# Question & Answer #6

## PIER 4 PHASE 2 RECONFIGURATION PROJECT NO. 091251 | CONTRACT NO. 070136

Submitted by Lighting Group NorthwestChris Hamaker		Catalog Number: FT6QLIC-LB6LEDA10L-40K-XX	Type: <b>RL3</b>
lighting group northwest	Job Name: Port of Tacoma - Pier 4 - Phase 2 Marine Building Phase Architect: TCF Architecture (Tacoma) Engineer: BCE Engineers (Fife)	Notes:	LGNW16-47554

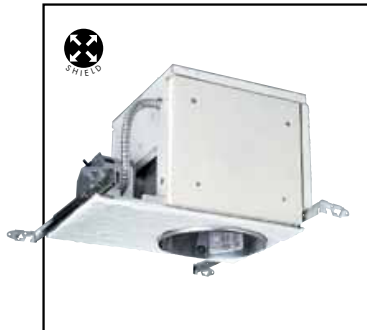
Attached is our lighting submittal for Port of Tacoma Pier 4. We have also sent a copy of this prior submittal to the engineer, Chuck Heaton with BCE Engineers. (Attachment A)

Submitted Lighting Controls by Hubbell are approved equal. Fixture RL3 and RL3E - Disapproved, fixture shall have marine grade finish.
